CITY OF ALBUQUERQUE

**RE: 9401 Black Farms Lane
2nd Revised Grading and Drainage Plan
Engineer's Stamp Date: 03/24/22
Hydrology File: C13D027C**

ENGINEER'S SEAL	9401 BLACK FARM LN, N.W.	DRAWN BY WCVJ
 <div>4/14/21  12/27/17 3/24/22 </div>		DATE 12-27-17
		21811-LAYOUT-10-16-17
DAVID SOULE P.E. #14522	GRADING AND DRAINAGE PLAN	SHEET # —
	 <div>Rio Grande Engineering 1606 CENTRAL AVENUE SE SUITE 201 ALBUQUERQUE, NM 87106 (505) 872-0999</div>	JOB # 21808

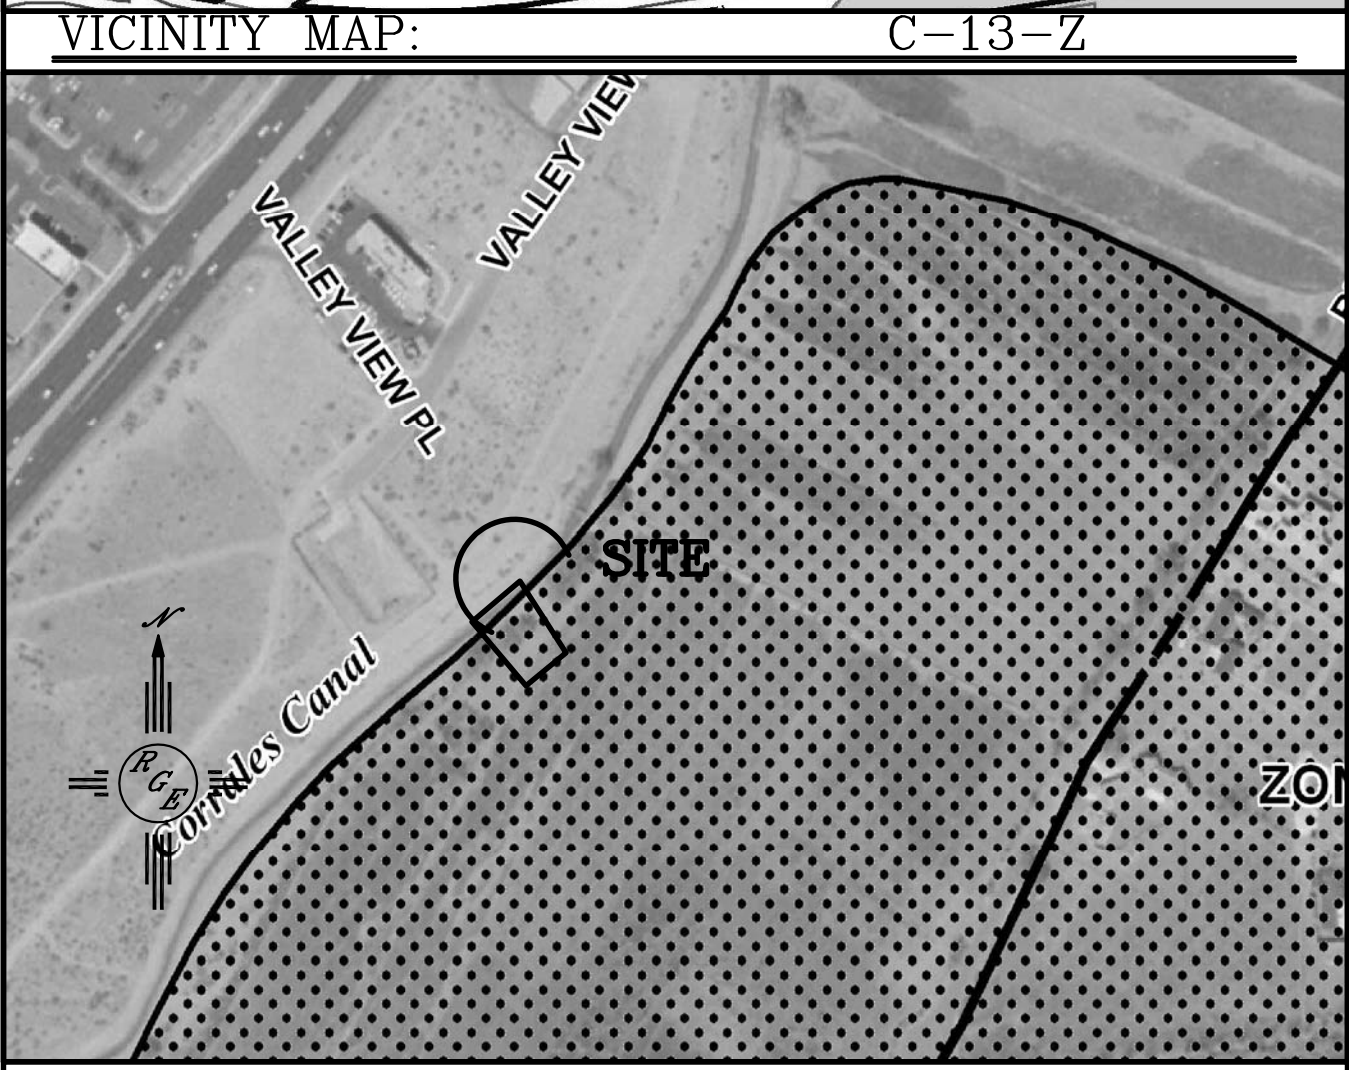
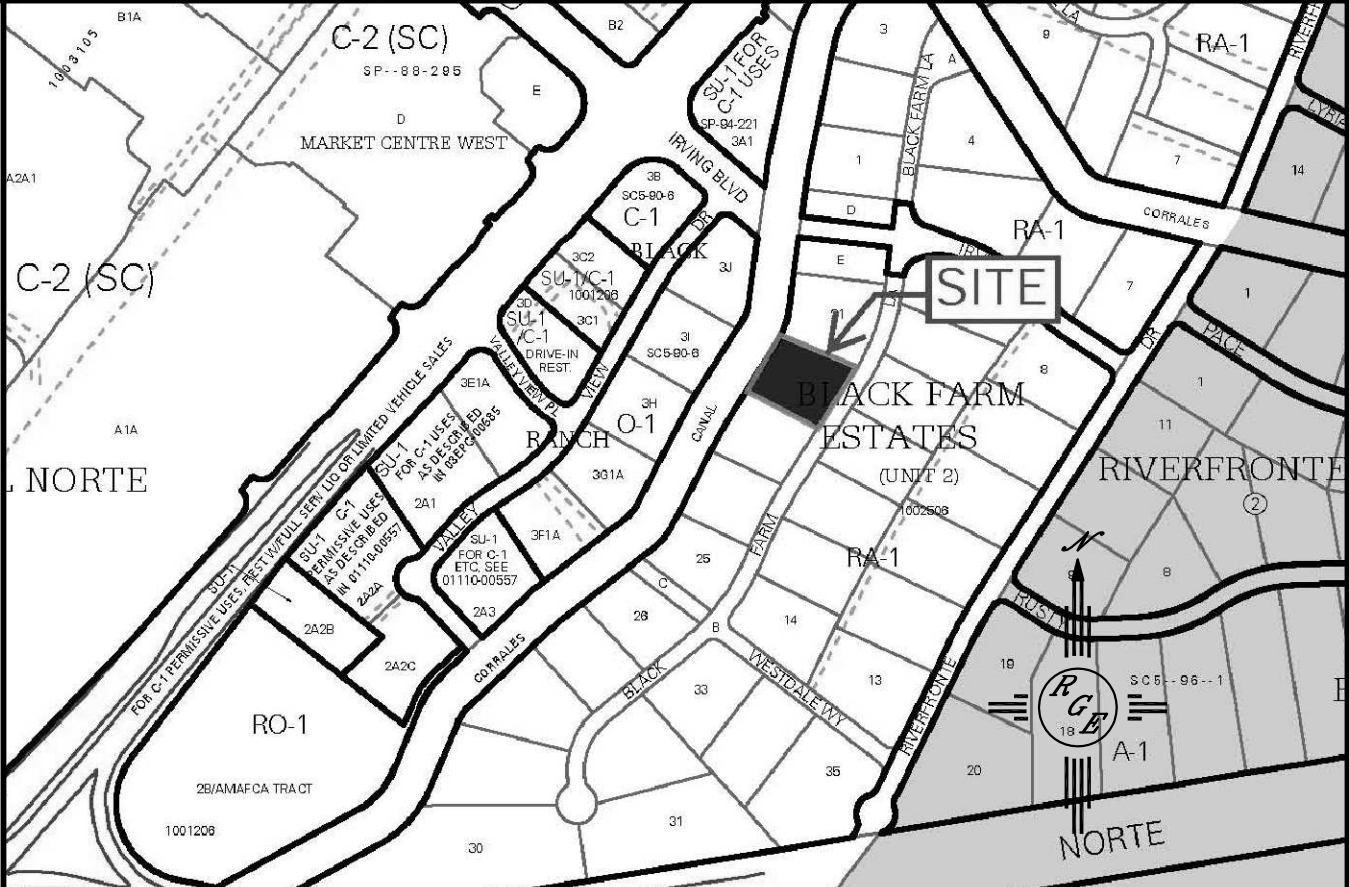
Based upon the information provided in your submittal received 03/24/2022, the 2nd Revised Grading and Drainage Plan is approved for Grading Permit and Building Permit. Please attach a copy of this approved plan in the construction sets for Building Permit processing along with a copy of this letter.

1. Engineer's Certification, per the DPM Part 6-14 (F): Engineer's Certification Checklist For Non-Subdivision is required.
